Docket Nos.: 50-358, 50-352/353, 50-367, 50-373/374, 50-387/388,  
50-410, 50-322, 50-397

APPLICANT: Members of Mark II Owners Group

SUBJECT: MEETING WITH MARK II OWNERS GROUP TO DISCUSS THE STAFF'S  
MARK II CONTAINMENT ACCEPTANCE CRITERIA RELATED TO  
SUBMERGED STRUCTURE DRAG LOADS - NOVEMBER 15, 1978

ACCELERATION DRAG PRIOR TO IMPACT

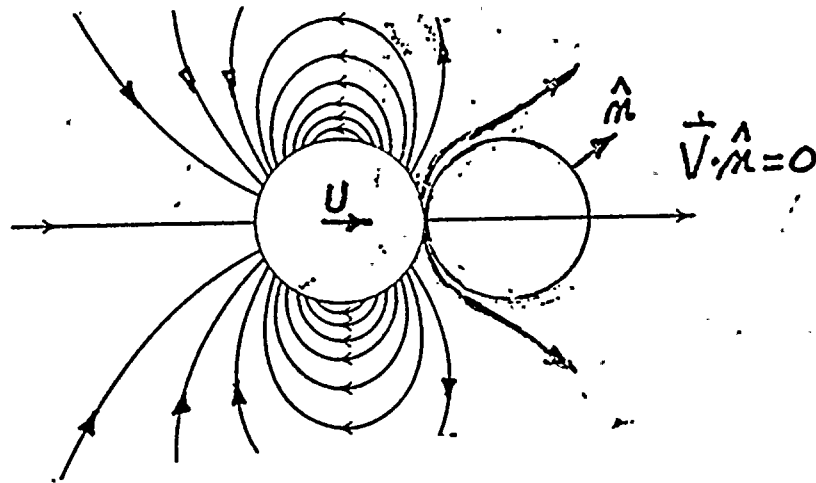
FLOW FIELD UNDISTURBED BY STRUCTURE:  $R_A/s \sim 6$

FLOW FIELD SATISFIES ZERO NORMAL VELOCITY BOUNDARY CONDITIONS:

$R_A/s \sim -3/64$

## WATER JET EXPERIMENTS

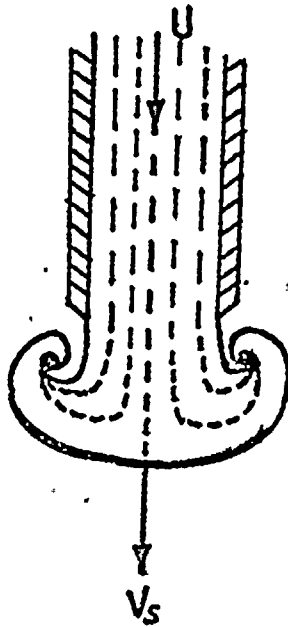
- FILMS OF 1/13.3 AND 1/4 SCALE TESTS SHOW MUSHROOM NOT BULLET.

- JET KINETIC ENERGY CONVERTED INTO VORTICITY.
- MOVEMENT OF VORTEX RING PRODUCES FLOW FIELD IN POOL.

CONCLUSION: RING VORTEX MODEL CAN BE EXPECTED TO PREDICT VENT CLEARING.

The Mark II owners showed films of scaled tests to support their argument that the penetration of the water jet is limited, since the jet assumes a mushroom shape upon entrance into the pool. They maintain that a substantial fraction of the kinetic energy of the jet is converted into vorticity. Thus they conclude that a good representation of the flow field can be generated by an analytical model based on the movement of a vortex ring. This model is currently under development by the Mark II owners. The staff stated that this approach appears promising. However, it is doubtful that we would receive documentation describing the model in time for its use by the lead plant applicants.

Figure 1. Total Force on Cylinders, Constant Acceleration (Sarpkaya and Garrison, 1953)

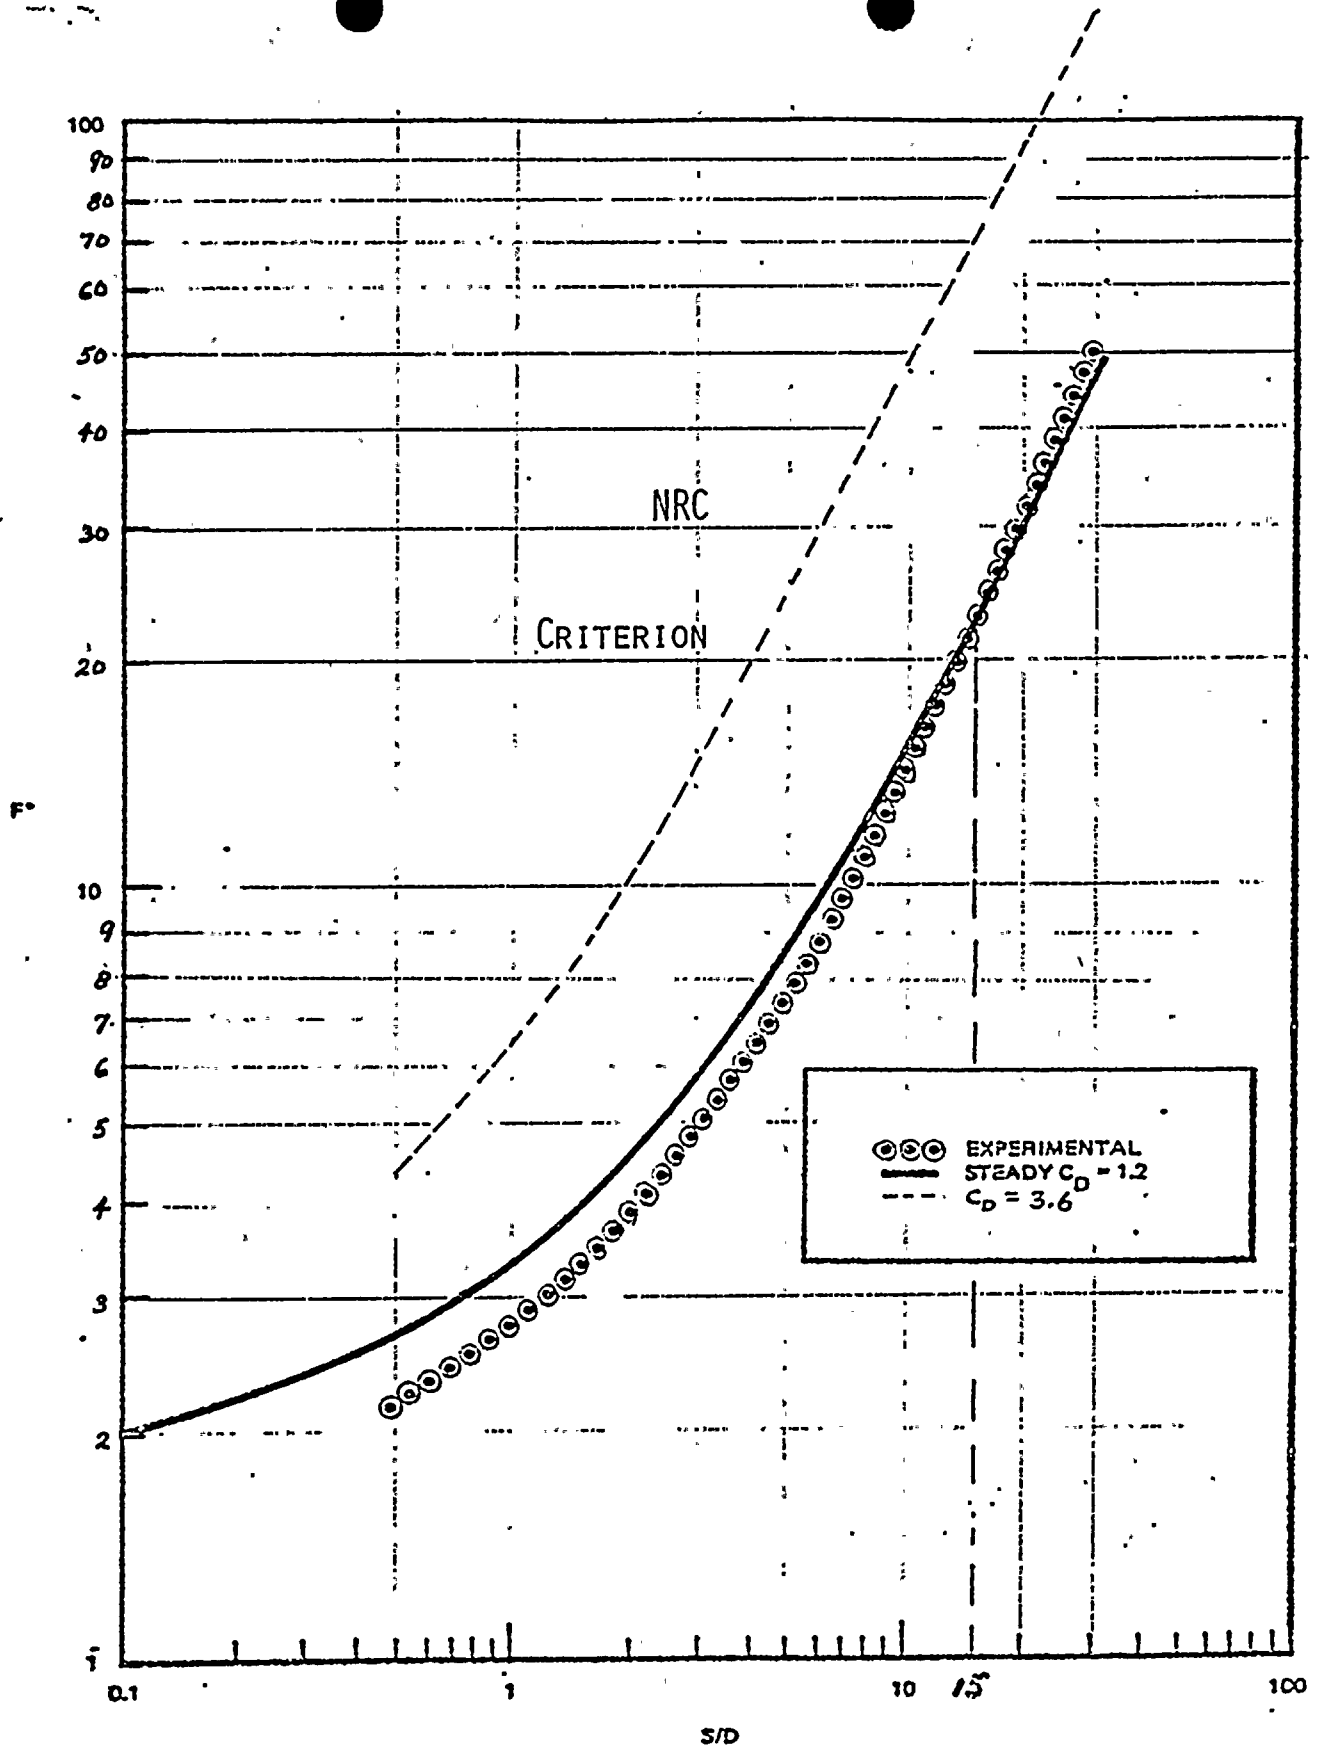
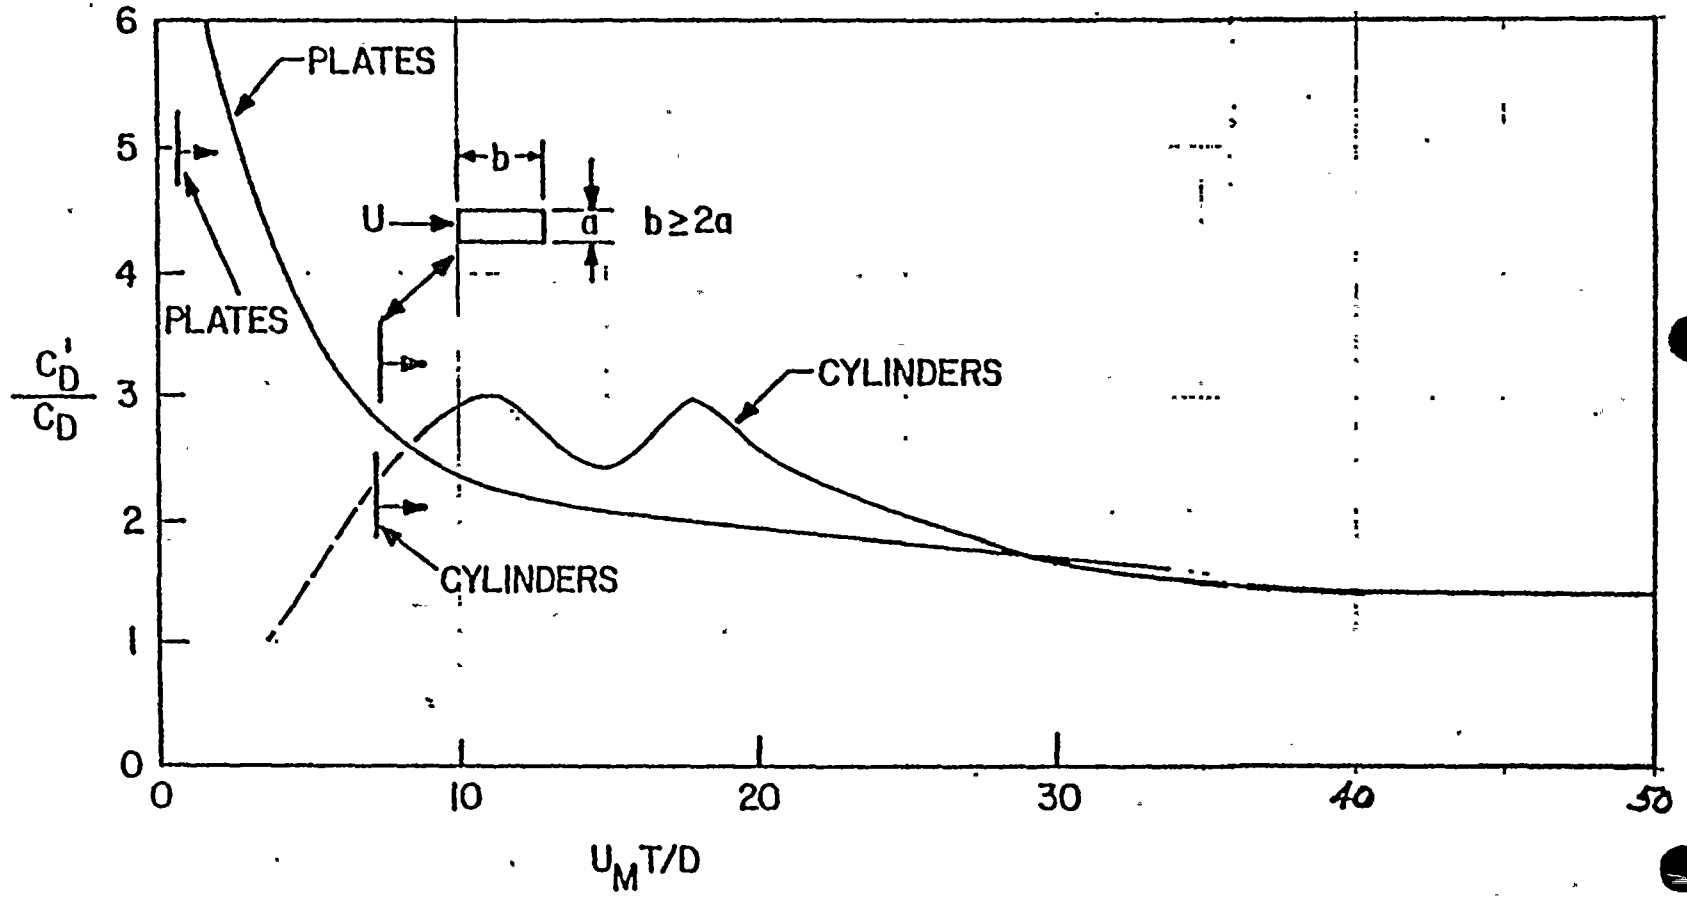
(B) MODIFY DRAG COEFFICIENT  
BY  $C_D^*/C_D = 3$

(B) USE EXPERIMENTAL  
LITERATURE TO DETERMINE  
APPROPRIATE VALUE OF  $C_D^*/C_D$

- 0 ANALYSIS OF APPLICABLE EXPERIMENTAL DATA INDICATES THAT 1.4 IS AN UPPER BOUND FOR  $C'_D/C_D$  (RATHER THAN 3)\*. APPROPRIATE FACTORS WILL BE CALCULATED DEPENDENT UPON INDIVIDUAL PLANT GEOMETRY.

- 0 USE OSCILLATING FLOW RESULTS AT CORRESPONDING KEULEGAN-CARPENTER NUMBER FOR POOL-SWELL.

Our criteria for acceleration drag coefficients used in the calculation of air bubble associated drag loads are based on a bounding approach. A value of three times the standard drag coefficient was chosen to bound both the situation of uniform flow characteristic of most pool swell phenomena and the oscillating flow that is characteristic of SRV actuation. The Mark II owners proposed a modification to our criteria wherein they would specify separate criteria for uniform and oscillating flow fields. For uniform flow fields, unpublished data of Sarpkaya was referenced which indicates that an upper bound of 1.4 can be justified for the standard drag multiplier. For oscillating flow fields, they propose direct application of the Keulegan-Carpenter corrections for standard drag coefficients. The staff stated that the proposed approach appeared reasonable and that the unpublished data of Sarpkaya should be submitted to substantiate their proposed uniform flow field criteria.

TARGET LOCATIONS IN QSTF

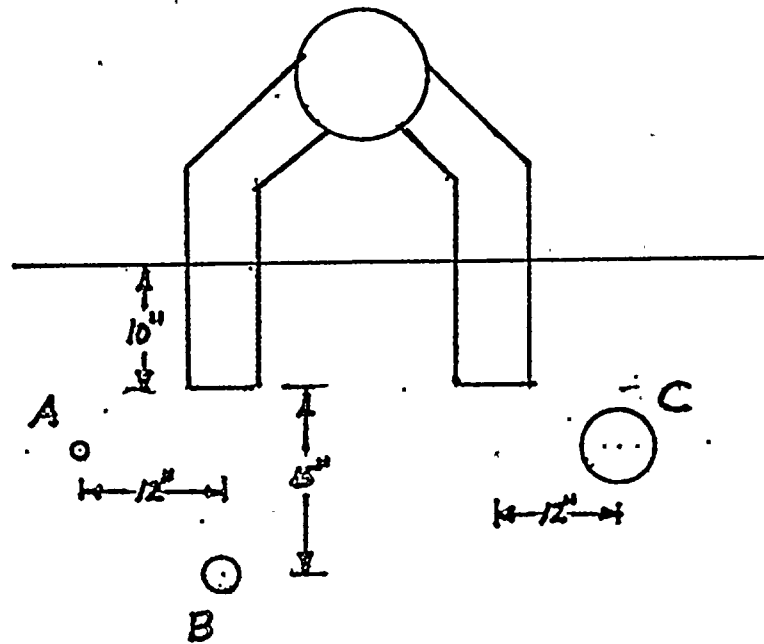
<u>TARGET</u>	<u>MODEL PREDICTION(LBF)</u>	<u>QSTF MEASUREMENTS(LBF)</u>
A	50	3
B	30	5
C	290	65

- 0 ANALYTICAL MODEL VERY CONSERVATIVE

EQUIVALENT UNIFORM FLOW ACCELERATION

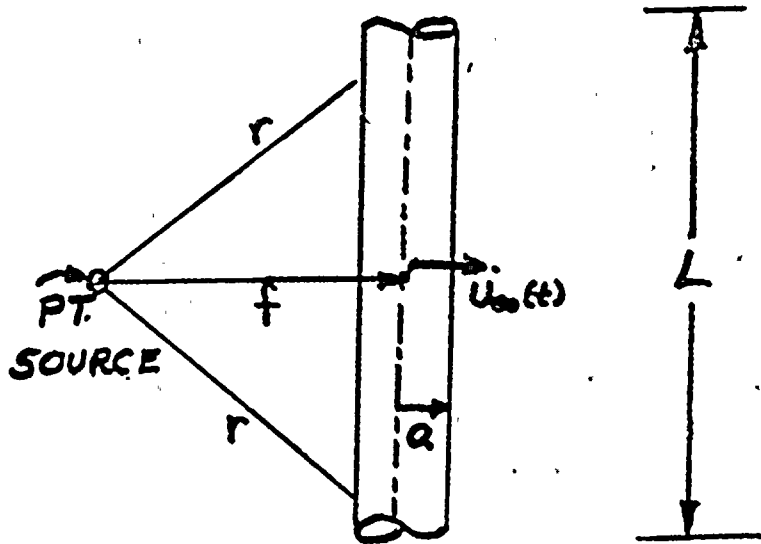
(c) TAKE MAXIMUM VALUES  
OF FLOW FIELD "SEEN"  
BY STRUCTURE

(c) USE CENTER LOCATION  
FOR ACCELERATION.

DEFINE MULTIPLIER TO  
BE APPLIED TO VELOCITY  
AT CENTER

$$\frac{F_A}{\rho \cdot 2\pi r^2 \dot{U}_{\infty}} = \left\{ \begin{array}{l} L \quad (\text{MOODY}) \\ \frac{L}{r} f \quad \left[ \frac{f}{r} < 1 \text{ for } L < \infty \right] \quad (\text{EXACT}) \\ 2F \quad \left[ \frac{L}{r} \rightarrow 2 \text{ as } L \rightarrow \infty \right] \quad (\text{TUNG EXACT FOR } L \rightarrow \infty) \end{array} \right.$$

The staff's criteria specify that the maximum velocity "seen" by the structure should be used in submerged structure drag calculations. The Mark II owners proposed use of the velocity at the center of the structure. The results of their analyses were provided to support their view that this methodology satisfies our criteria. In addition, they discussed problems they would have in applying our criteria. The flow field may be very complicated due to the presence of multiple sources and sinks. Thus, determination of the point of maximum velocity may be very costly. They proposed that sensitivity studies be performed by each A/E to define a multiplier that may be easily applied to the velocity calculated at the target

geometric center. The staff identified several problems associated with this approach. First, we stated that their argument for the velocity at the center of the target being a maximum did not cover the case of offset targets. The approach of establishing a simplified approach such as defining a multiplier to the velocity at the center of the target appears reasonable. However, we stated that this should be pursued generically instead of on a plant unique basis.

FIGURE C-1 ACCELERATION CORRECTION FOR STANDARD DRAG COEFFICIENT

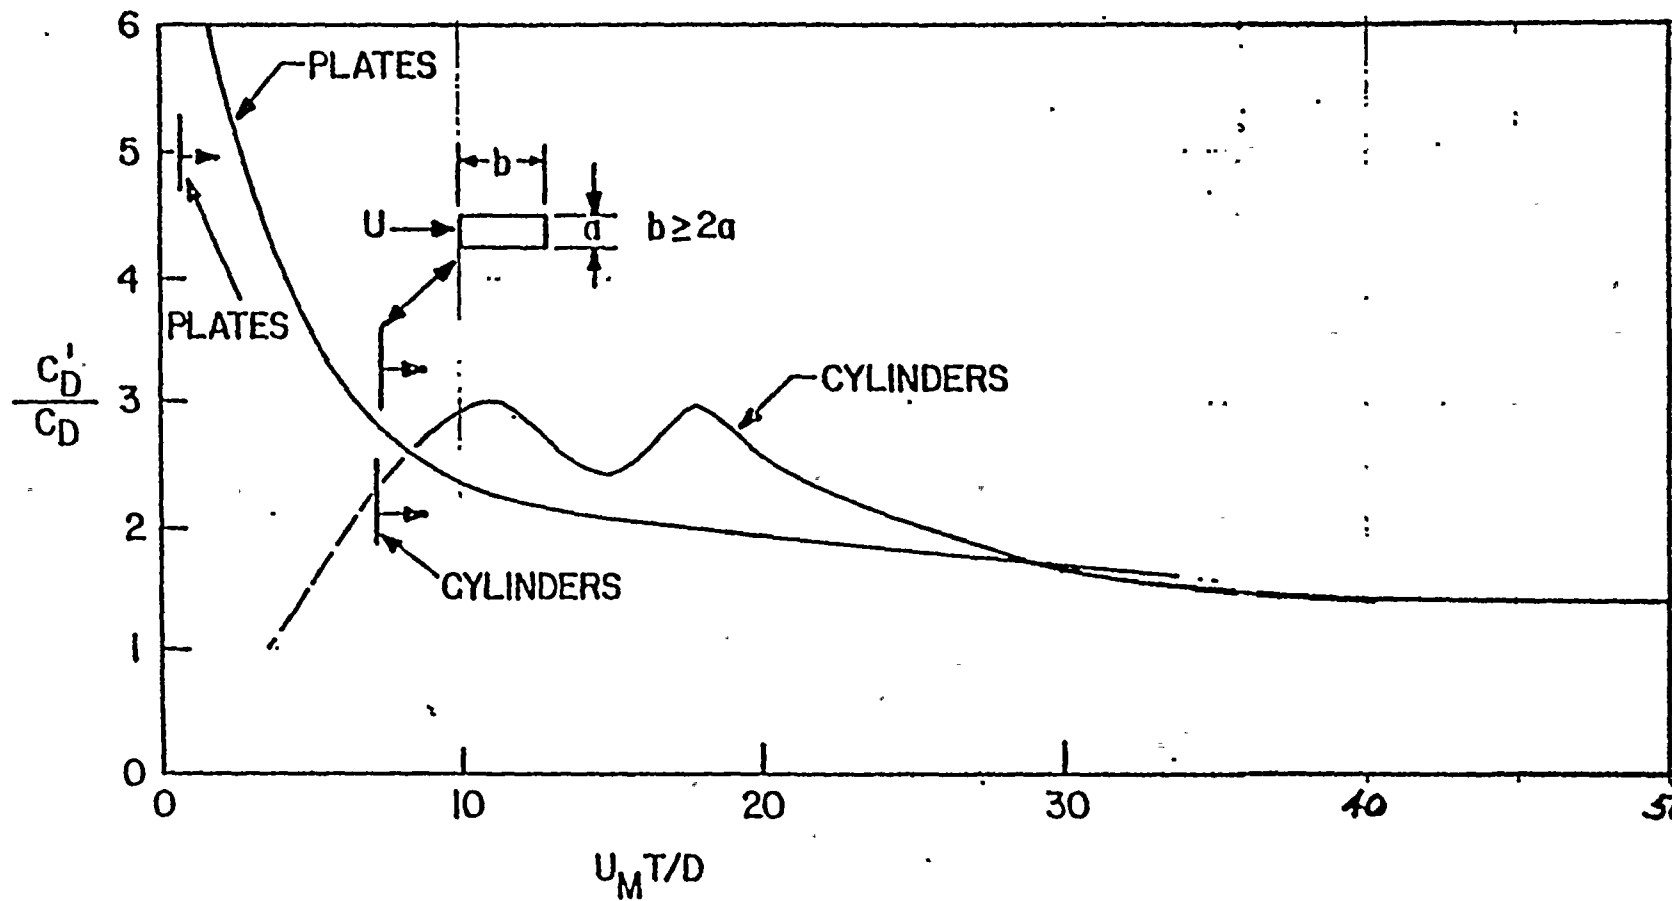
(B) USE OSCILLATING FLOW  
RESULTS TO OBTAIN  $C_D$ .  
POSITION IS SAME ON OTHER  
CONSTRAINTS AS IN LOCA  
AIR BUBBLE DISCUSSION.

- USE OSCILLATING FLOW RESULTS AT APPROPRIATE KEULEGAN - CARPENTER NUMBER TO DETERMINE  $C_D/C_{D1}$ .
- LOCA AIR BUBBLE CONCLUSIONS ON EQUIVALENT UNIFORM FLOW FIELD AND INTERFERENCE EFFECTS APPLY HERE ALSO.

Figure 1

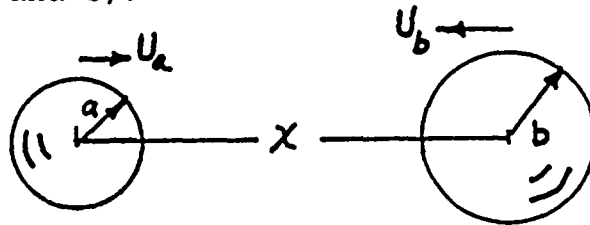
For the sake of argument, if the jet were to be modelable by a moving source of varying intensity, then the equation (1) of the reviewer (Reference 1) is correct. However, the subsequent arguments lead to overly conservative results. The force on a target at the time the jet front touches the target, if calculated as proposed by the reviewer, does not account for the presence of the target. To incorporate the correct target boundary conditions, one must represent the target with appropriate singularities and take the mutual images of these singularities in the axisymmetric half body (representing the jet slug) and the target. Without such a procedure, the condition of no flow through the target boundary is not satisfied.

Let us demonstrate the use of a correct procedure for a doublet approaching a rigid sphere. This corresponds to the case of two spheres approaching each other along the lines joining their centers, or to the case of one sphere approaching the other.

The correct formulation of the potential function through the use of many image doublets yields the kinetic energy,

For our criteria related to LOCA water jet loads, the Mark II owners provided the results of their analyses to determine the significance of the acceleration drag loads. These analyses include a disturbance of the jet flow field by the target such that a zero normal boundary condition is satisfied. This is in contrast to the staff's criteria which assumes that the flow field is not disturbed by the target. Their treatment of the flow field shows a potential for a large reduction in the staff's criteria for LOCA jet induced acceleration drag loads. However, the staff raised a number of questions regarding assumptions implicit in this new methodology. We require that these questions be resolved before these loads can be considered negligible.
